SAFETY DIRECTIVE – REPLACES SD 2018.01

No. 2018.01-1

SUBJECT: Titanium Autogyro (TAG) fitted with folding mast option

DIAGRAM 1. Identification of mast joiner plates (units of measurement are mm)

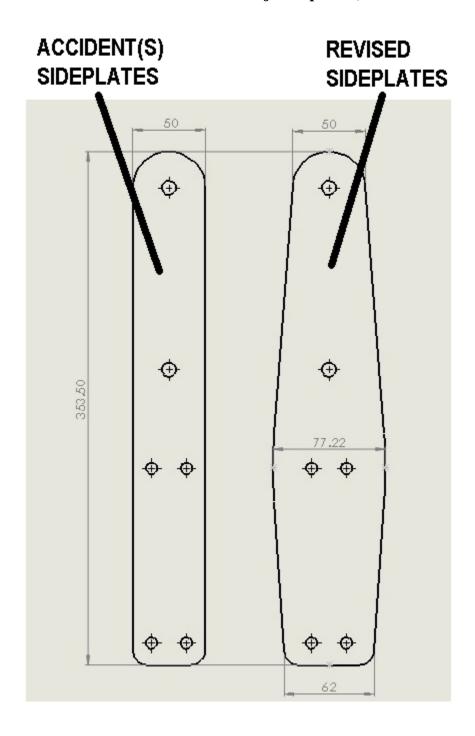
Titanium Autogyro (TAG) gyroplanes fitted with a folding mast and using the original version of the mast joiner plates (Version SP01) for the folding mast **remain grounded**. The original joiner plates can be identified by reference to the attached Diagram 1.

TAG Aviation Pty Ltd has submitted an Aeronautical Design Service Report by an aeronautical engineer to support that a revised version of the folding mast joiner plates (Version SP02) comply with the requirements of the ASRA construction standard. The revised mast joiner plates (Version SP02) can be identified by reference to the attached Diagram 1.

ASRA recommends that SP01 mast joiner plates are discarded to prevent any future misidentification. Folding mast variants that are retrofitted with revised mast joiner plates SP02 are permitted to fly under the following conditions;
